Access Compliance Report

Public Rights-of-Way

(Curb Ramps)

Intersection ID: 5151	Main Street: HAYBRIDGE_RD	Cross Street: RINDLE_CT	Location: NW
ADA ID: 3098E8BBABFA	Ramp Type: BlendTrans1	Initial Pass/Fail: Fail	Overall Compliance: No
Severity Score: 8.75			
Codes/Mitigation Info/Possible Solution		Field Measurements/Component Compliance

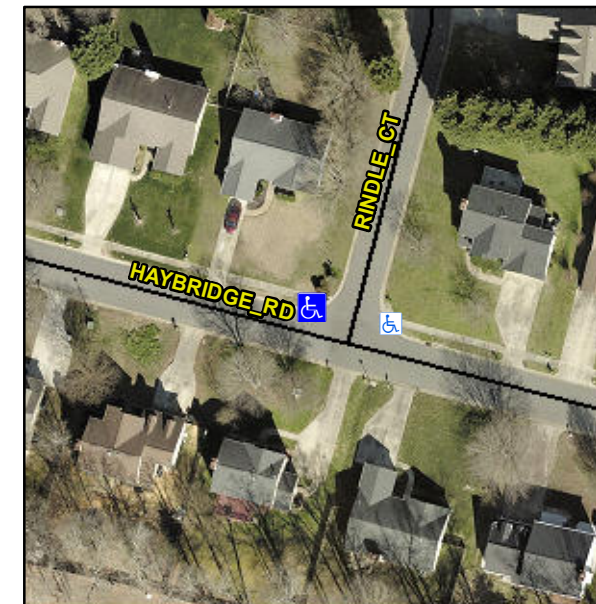
Remove & Replace Curb Ramp With Two New Directional Ramps or Equivalent.

R304.5.1
